City of Portland, Maine – Building or Use Permit Application 389 Congress Street, 04101, Tel: (207) 874-8703, FAX: 874-8716

BUILDING PERMIT REPORT

DATE: 27 Sept. 98 ADDRESS: 1359 Washington Ave. 401-A-006
 REASON FOR PERMIT: Signage
 BUILDING OWNER: MIKE ORR
 CONTRACTOR: Bailey Sign Inc.
 PERMIT APPLICANT: ↑
 USE GROUP Signage BOCA 1996 CONSTRUCTION TYPE _____

freestanding

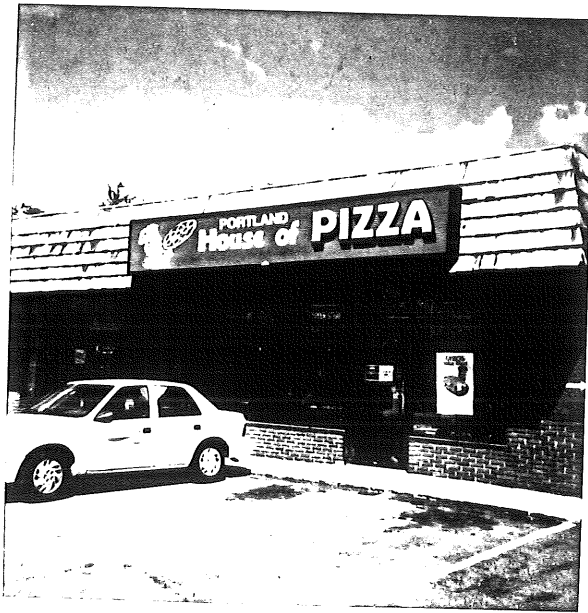
Area 65# max 48# show

height 18' max 16' show

PS. # **D-213** W.O. # _____

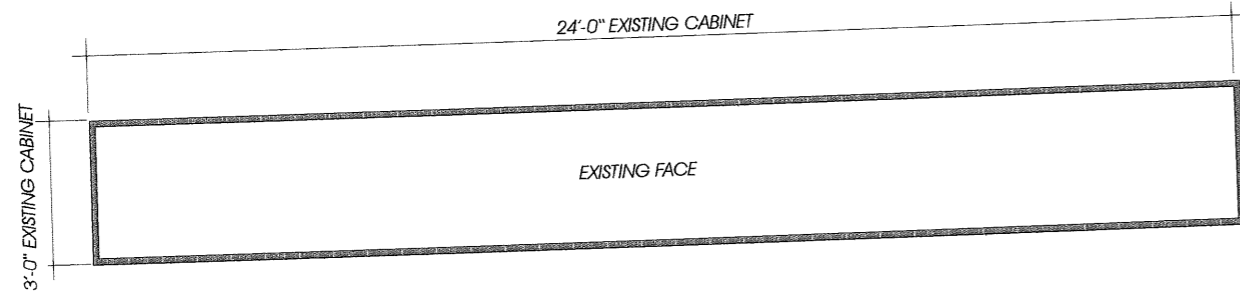
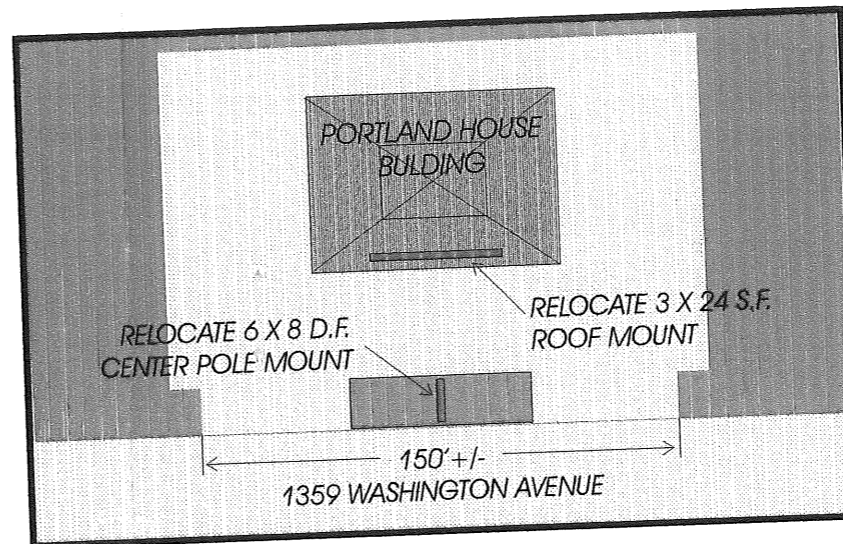
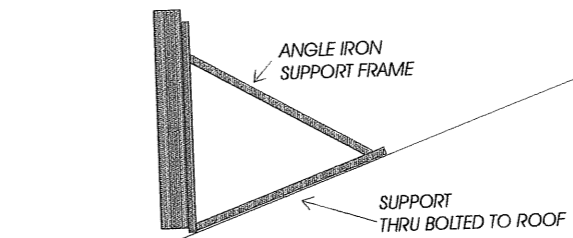
4/2/99 Pole Sign ok - Roof Sign design changed -
Amendment wasfiled w/ Marge - not found in file -
but checked new sign & OK
